## Public Comments Regarding GMA-12 DFC/MAG Preliminary Scenarios

Figure 1

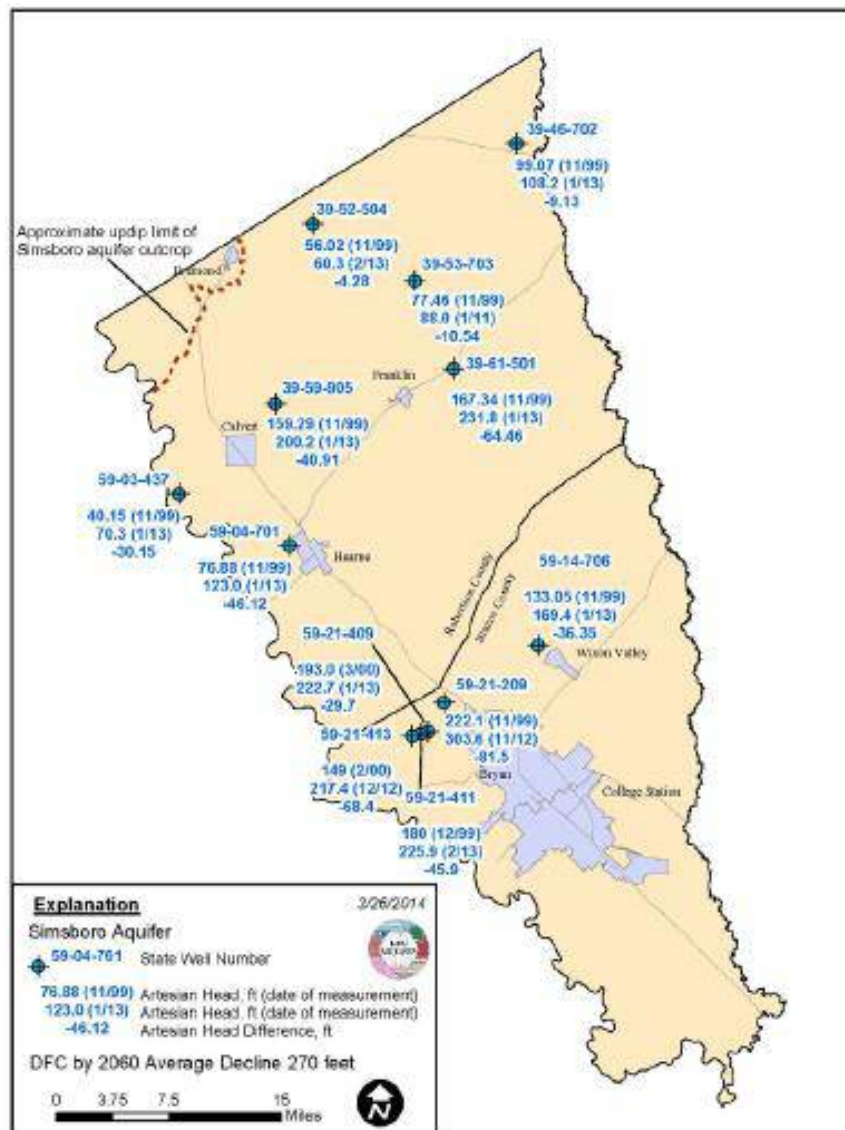
*In Robertson County the amount of artesian head decline is influenced by the increase in pumping for agriculture in the area west of Hearne. Even with that pumping, the head decline in Well 59-03-437 is a good indicator of aquifer artesian head change as that well is pumped on a limited basis. Well 59-03-437 is actually west of Calvert and is shown in Figure 1 as having an average drawdown of 30.15 feet. Well 59-04-001 is west of Hearne. At this time do not have a good explanation for the amount of artesian head decline in Well 39-61-501. Well 39-61-501 data shows a recorded static level of -231 ft. every month from 3/2013 to 8/2014. This is obviously abnormal but was still included in the "average."*

The DFC is an average of 270 feet of artesian head decline occurring by 2060. If we take the average for the 12 wells measured, the artesian head decline is about 39 feet for the period 2000 through about the beginning of 2013. First, why not take all 59 Simsboro monitored wells? Second, why select 1/2013 for the end date when several more months of collected data was available? Third, why take an average of these wells, when plotting trend lines would have been a much better indicator of our actual decline?

Figure 2

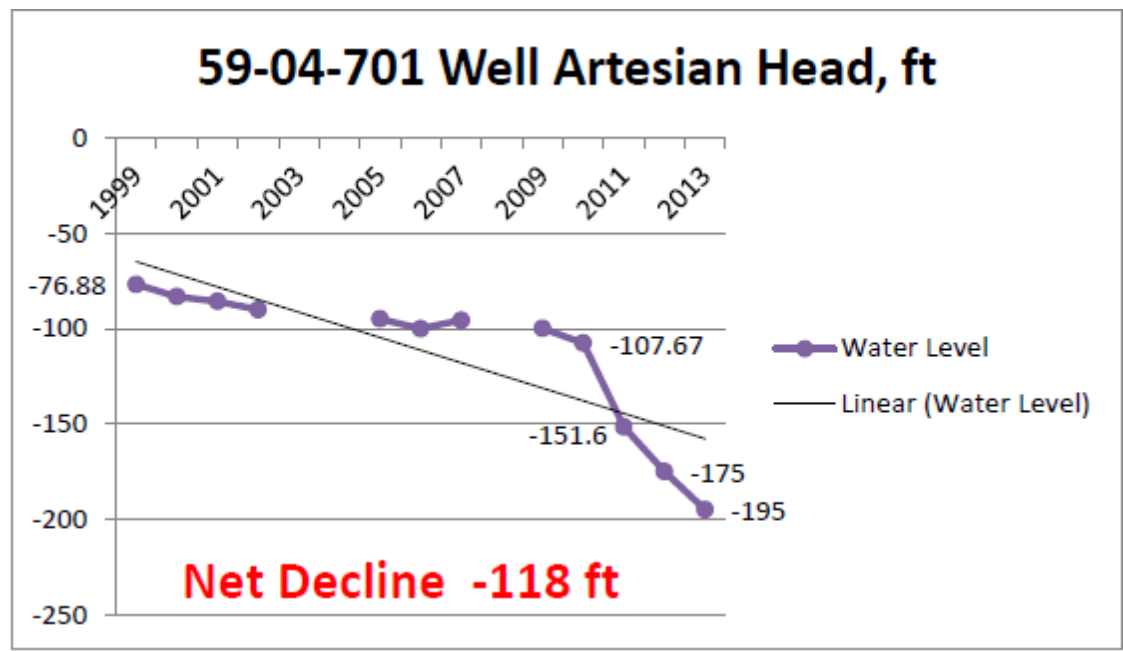
7. Well 59-04-701 is a municipal well located within 5 miles of several large producing agricultural wells. This well is not a primary well used by the City of Hearne residents. Please note the dramatic decline of water levels beginning in 2010 in Figure 2. This coincides with the arbitrated settlement of contested permits and the beginning of an annual 20,000 ac.ft. withdrawal of the Simsboro groundwater for agricultural irrigation west of Hearne.

## Attachment A

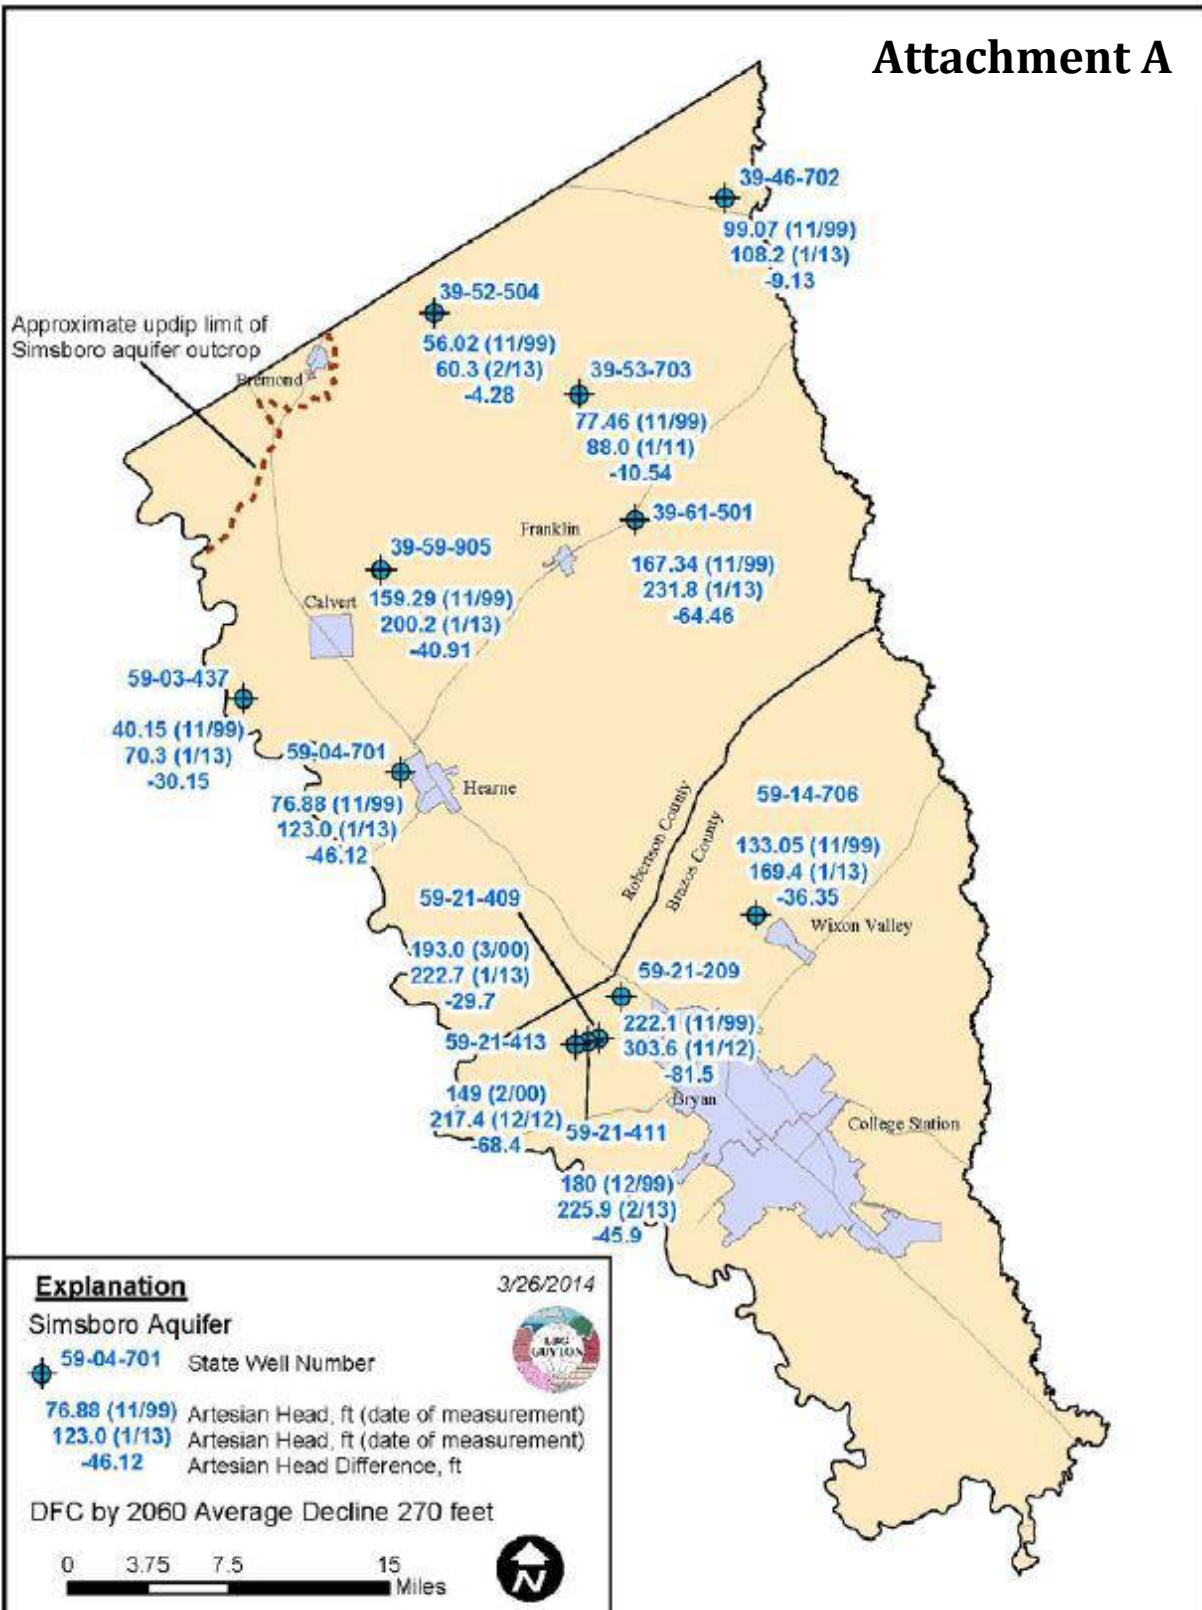
Of the twelve selected wells, please consider the following seven in Robertson County as identified above (also Attachment A).

1. Well 39-52-504 is located in northern Robertson County a good distance from the primary producer of Simsboro groundwater and is over the Simsboro outcrop.

2. Well 39-46-702 is located in the NE corner of Robertson County a good distance from the primary producer of Simsboro groundwater, near the Navasota River and Lake Limestone and over the Carrizo-Wilcox outcrop zone.

3. Well 39-53-703 is a domestic/livestock well with no reading dated 1/11 on water level report and the last reading was taken in 7/2011. There have been no recorded readings since 7/2011. This well is over the Carrizo-Wilcox outcrop zone.

4. Well 39-61-501 is the well mentioned above with the identical water levels for 14 consecutive months.
5. Well 59-03-437 is very close to the Brazos River and "pumped on a limited basis."

6. Well 39-59-905 is a domestic/livestock well NE of Calvert with no reading dated 1/11 on the water level report and is over the Carrizo-Wilcox outcrop zone.
